Illinois Tollway Standard Drawings Revisions

Section L Base Sheet Drawings		
Drawing	Modification Summary	Effective: 03-01-2021
L1 Fiber Optic System Typical and Drawings		
Sheet 1	Updated General Note #4 to include "Fiberglass Reinforced Epoxy (FRE) conduit may be used above ground or underground (as casing) per the Special Provisions. HPDE conduit casing may be used underground."

VERSION: 2021-03	STANDARD: L1-03	SHEET: 10 OF 15
---------------------	--------------------	--------------------

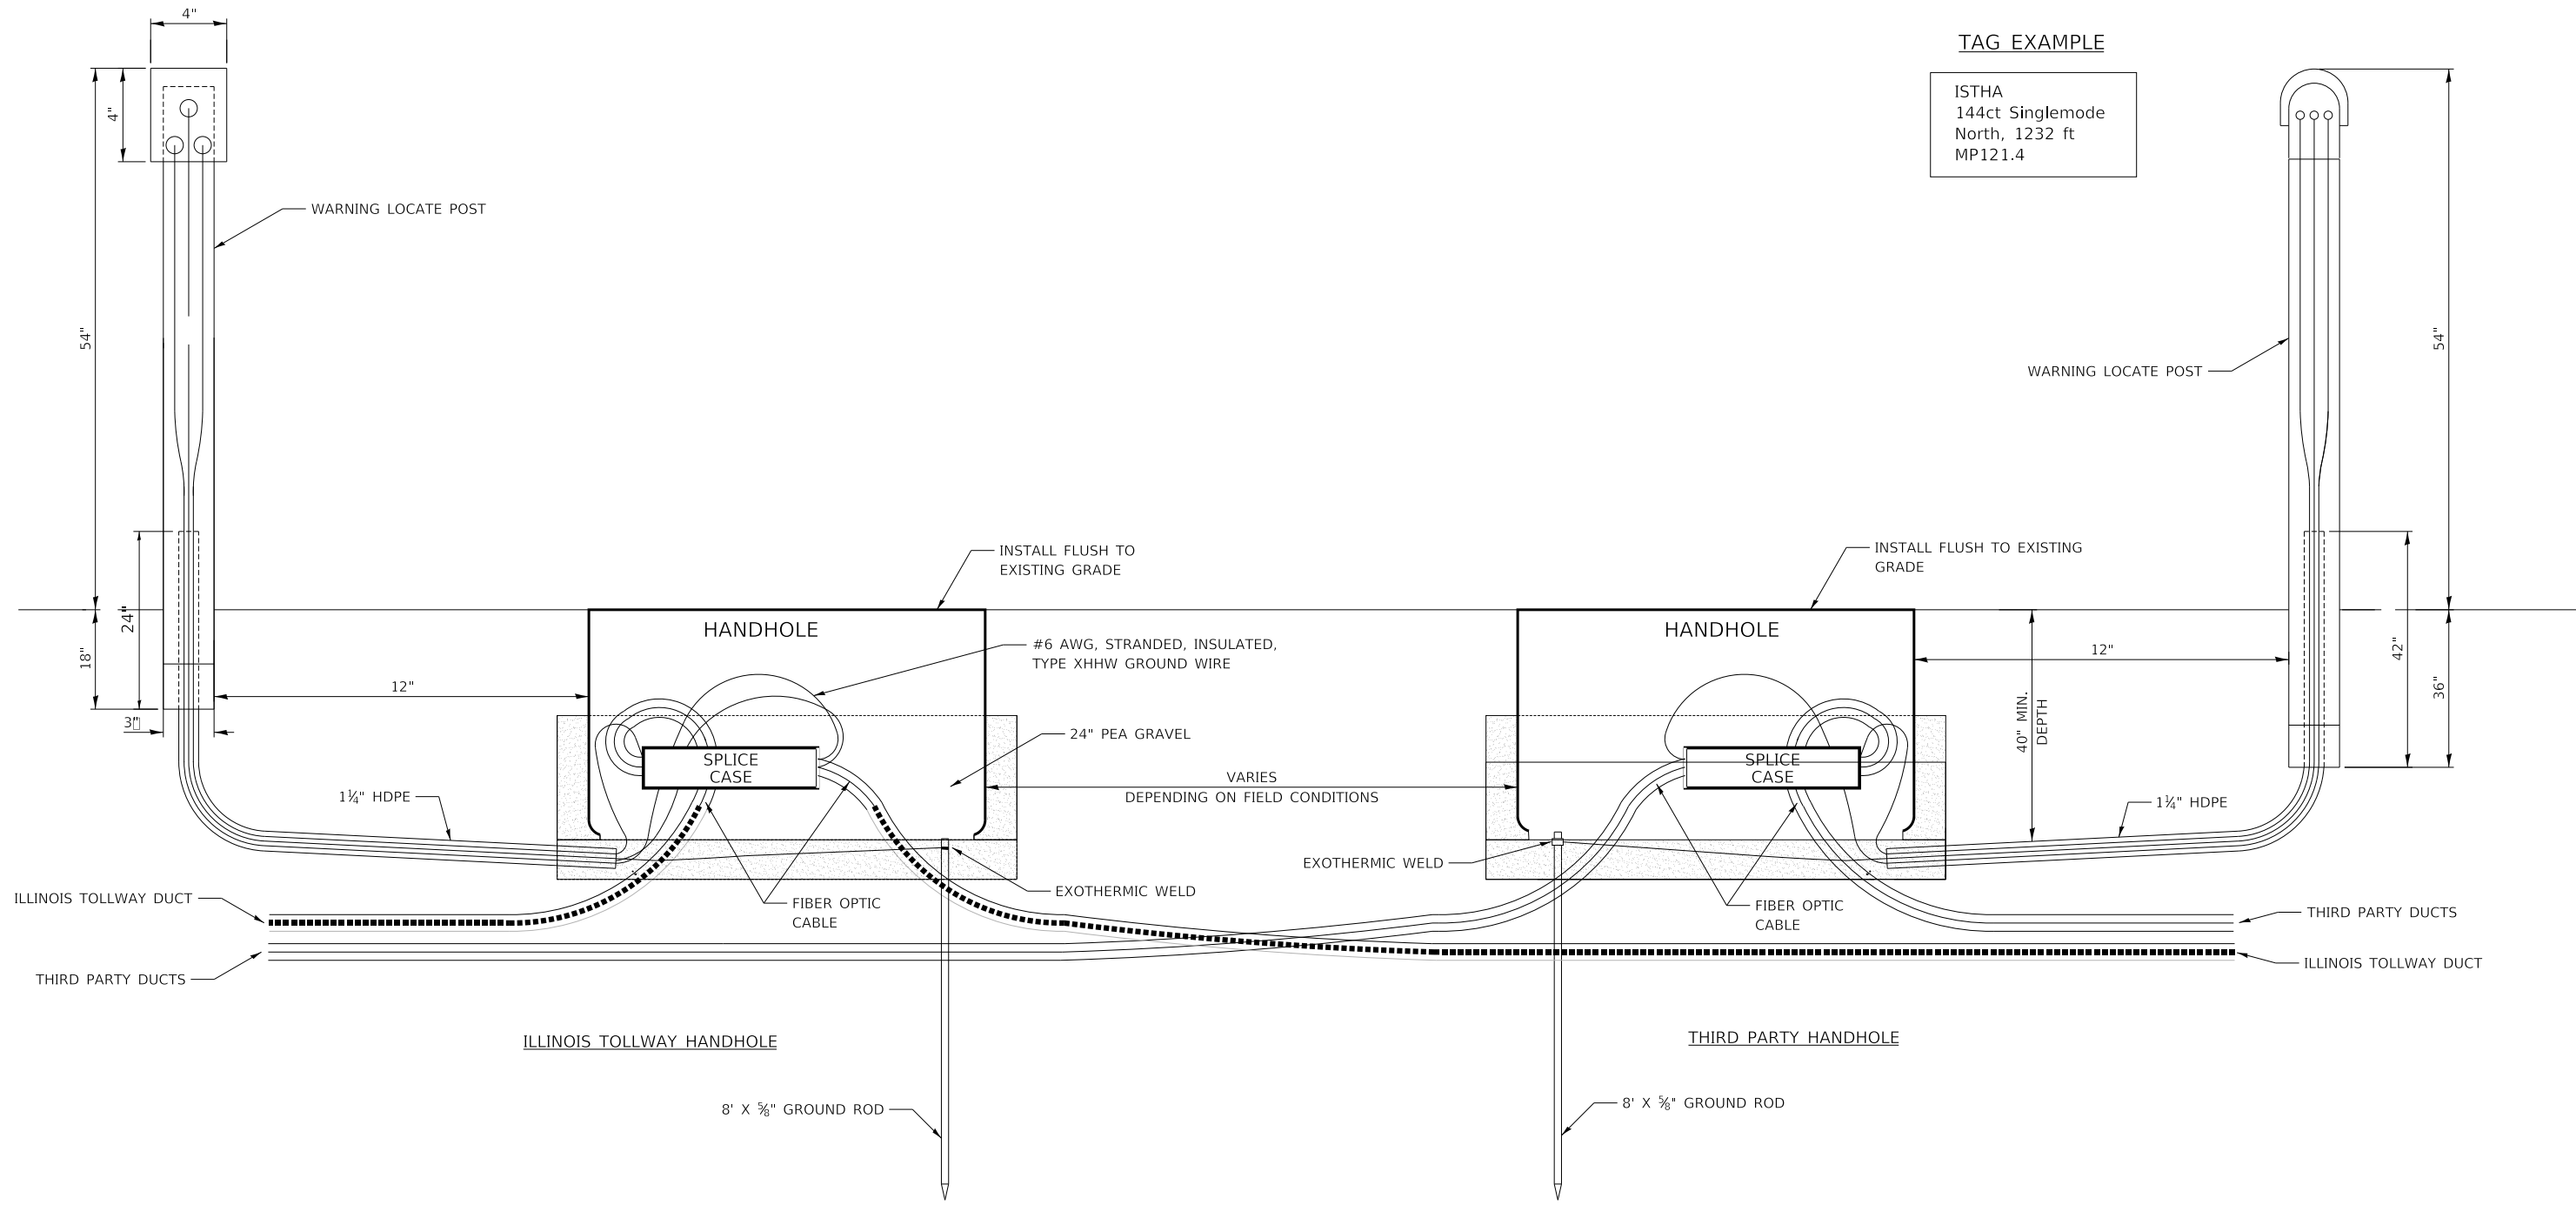
Sheet 9	Removed "Placed 1 1/4" HDPE" from Handhole - Plan View.	
Sheet 10	Removed note "Place 1 1/4" HDPE over fiber optic cable to provide crush protection extend HDPE 1" inside handhole."

VERSION: 2021-03
STANDARD: L1-03
SHEET: 13 OF 15

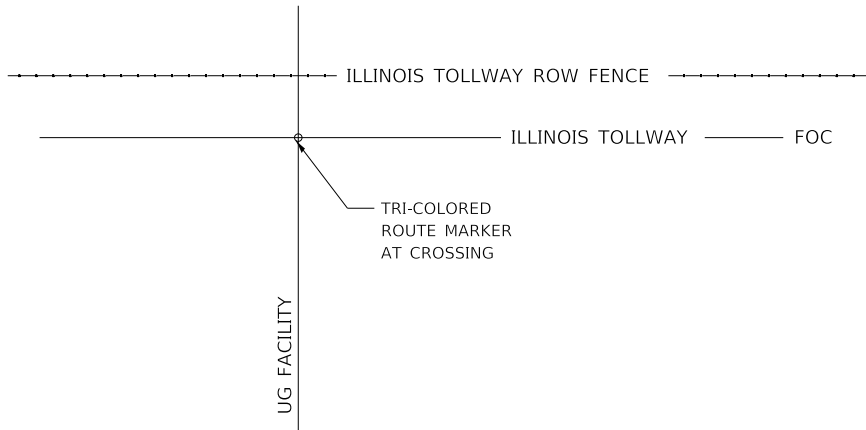
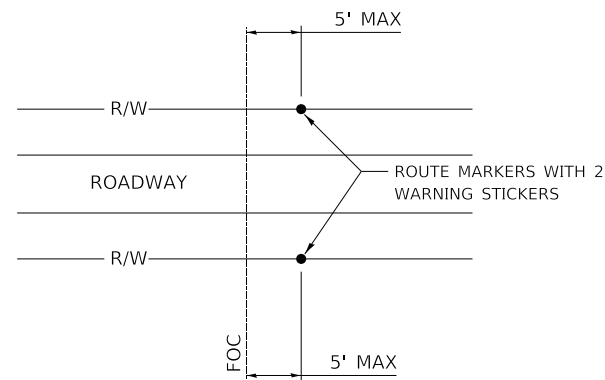
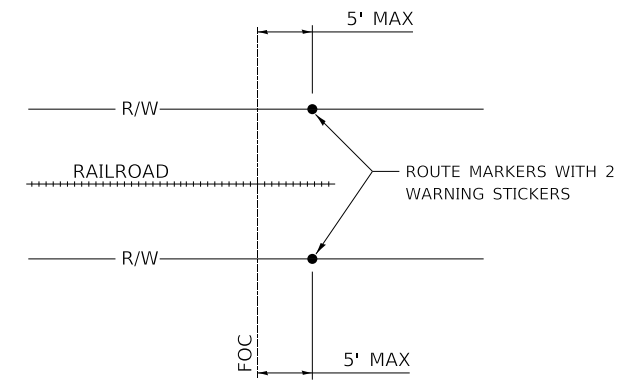
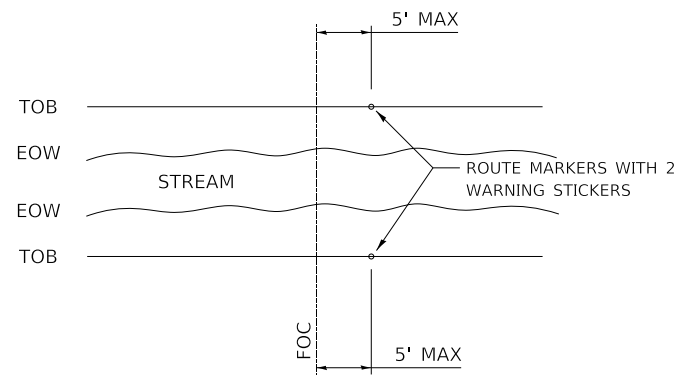
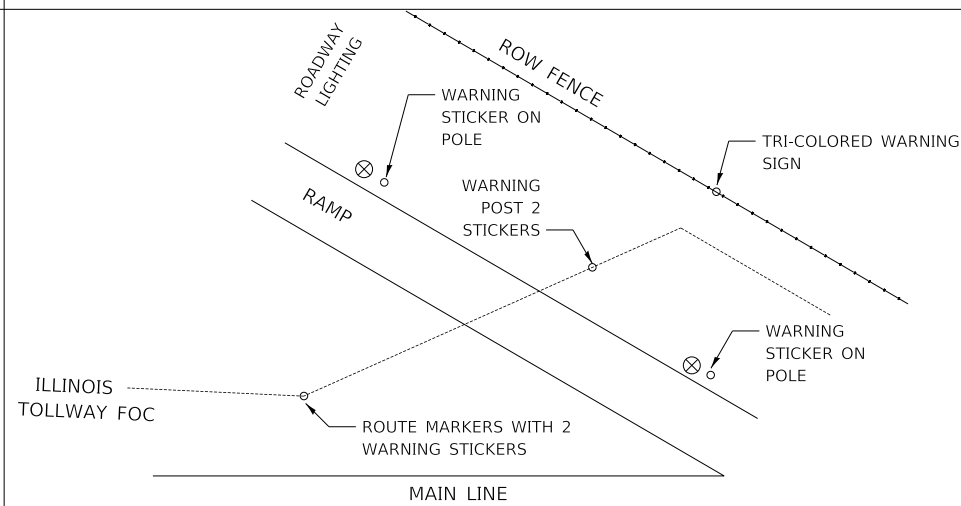
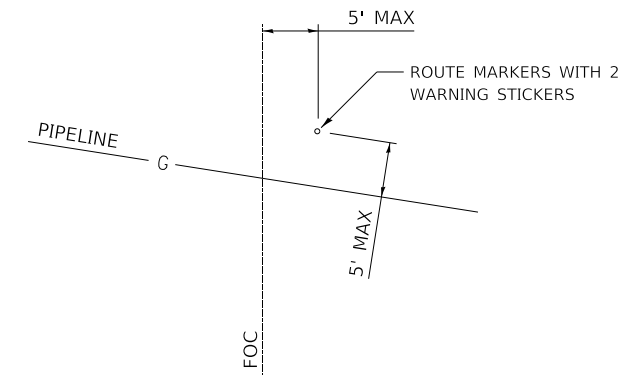
Sheet 13	Relocated route marker to be placed directly above utility crossings	
Sheet 13	Add the word "max" to all distances.	
L2 Fiber Optic Splicing Details

VERSION: 03-01-2021 STANDARD: L2-02 SHEET: 1 OF 2

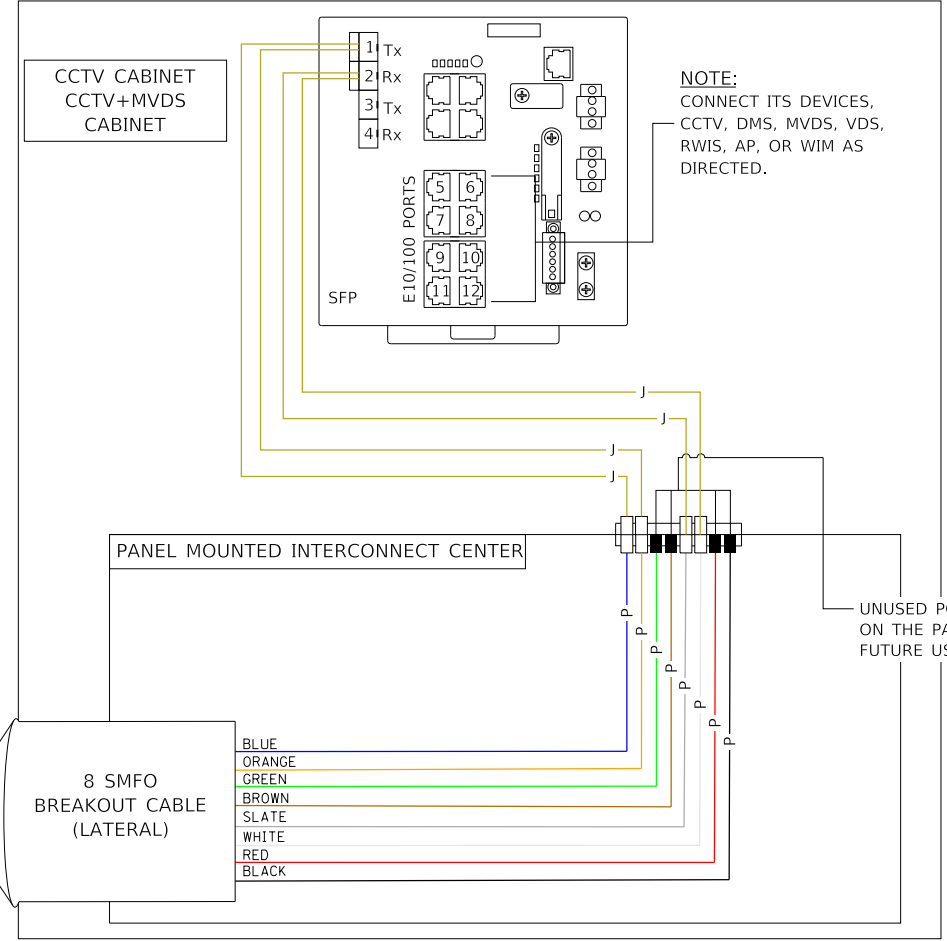
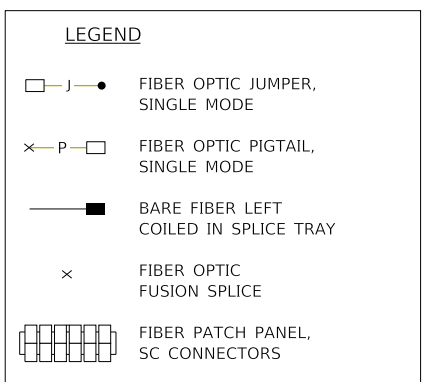
Sheet 1	Added "AP" to the list of connected ITS devices.	
Sheet 1	Updated the fiber distribution panel connection schematic.	
Sheet 1	Updated the network switch to depict the 12 port IE-4000 ethernet switch.

VERSION: 03-01-2021	STANDARD: L2-02	SHEET: 2 OF 2
---------------------	-----------------	---------------

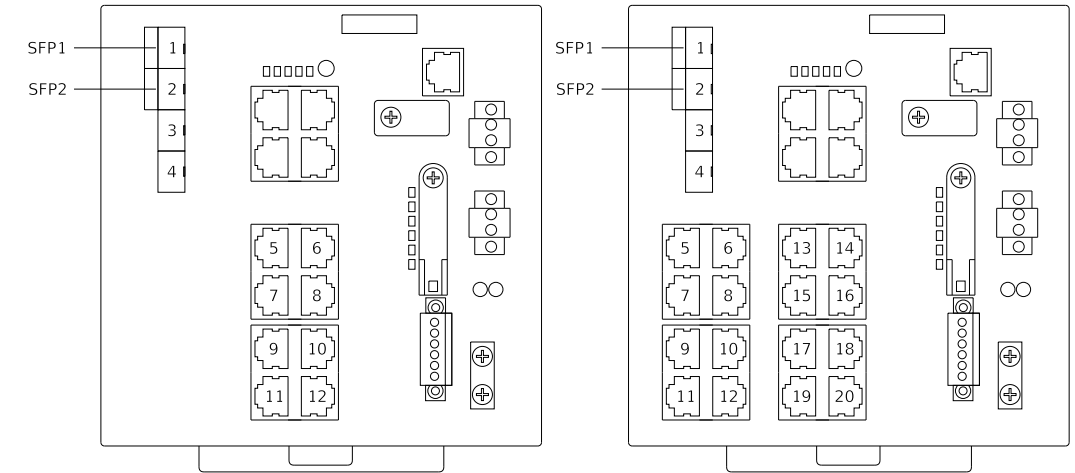
Sheet 2	Replaced the IE-3000 Cisco Ethernet Switch to the IE-4000 12/20 port Cisco Ethernet Switch.	
Sheet 2	Replaced the Cisco Ethernet Switch and Expansion Switch with two 9300 Cisco Ethernet Switches.

Sheet 2	Updated all port tables.
